ILLINOIS POWER COMPANY

U-600126
L30-85(07-12)-L
058-85(07-12)-L
1A.120

Subject: Clinton Power Station Unit 1
Thermal Hydraulic Stability
SER License Condition #2

FIGURE 3.4.1.1-1

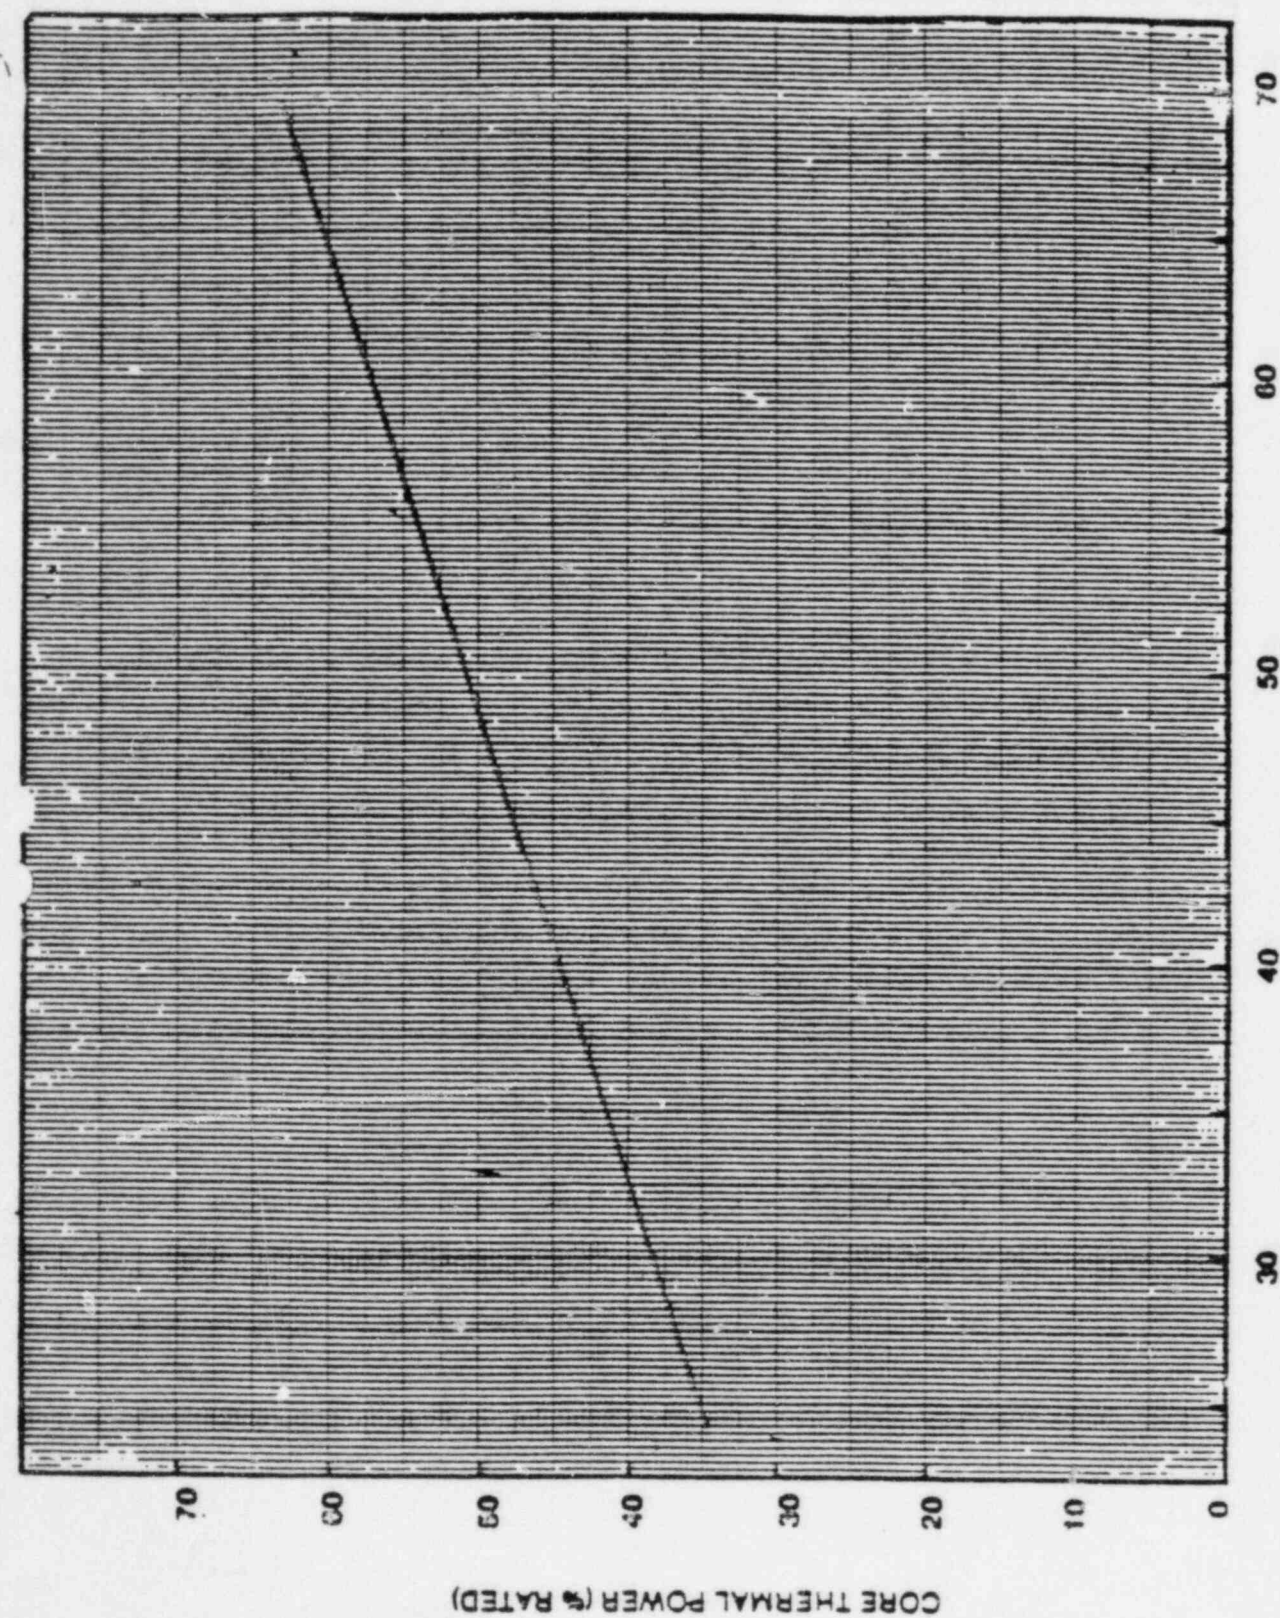
- a. Total core flow greater than or equal to 45% of rated core flow, or
- b. APRM or LPRM** noise levels within the operating region for which monitoring is required (surveillance 4.4.1.2) not larger than three times their established baseline noise levels.

- a. With one reactor coolant system recirculation loop not in operation immediately initiate action to reduce THERMAL POWER to less than or equal to the limit specified in Figure 3.4.1.1-1 within 4 hours and initiate measures to place the unit in at least HOT SHUTDOWN within the next 12 hours.

- b. With no reactor coolant system recirculation loops in operation, immediately initiate action to reduce THERMAL POWER to less than or equal to the limit specified in Figure 3.4.1.1-1 within 4 hours and initiate measures to place the unit in at least STARTUP within 6 hours and in HOT SHUTDOWN within the next 6 hours.

- c. With two reactor coolant system recirculation loops in operation and total core flow less than 45% of rated core flow and THERMAL POWER greater than the limit specified in Figure 3.4.1.1-1, and with the APRM or LPRM** neutron flux noise levels greater than three times their established baseline noise levels, immediately initiate corrective action to restore the noise levels to within the required limits within 2 hours by increasing core flow to greater than 45% of rated core flow or by reducing THERMAL POWER to less than or equal to the limit specified in Figure 3.4.1.1-1.

4.4.1.2 When total core flow is less than 45% of rated flow with two coolant system recirculation loops in operation and THERMAL POWER is greater than the limit specified in Figure 3.4.1.1-1, establish a baseline APRM and LPRM** neutron flux noise value within 2 hours of entering this operating region unless baselining has previously been performed in the region since the last refueling outage.

Stability tests at operating BWRs were reviewed to determine a generic region of the power/flow map in which surveillance of neutron flux noise levels should be performed. A conservative decay ratio of 0.6 was chosen as the bases for determining the generic region for surveillance to account for the plant to plant variability of decay ratio with core and fuel designs. This generic region has been determined to correspond to a core flow of less than or equal to 45% of rated core flow and a THERMAL POWER greater than that specified in Figure 3.4.1.1-1.
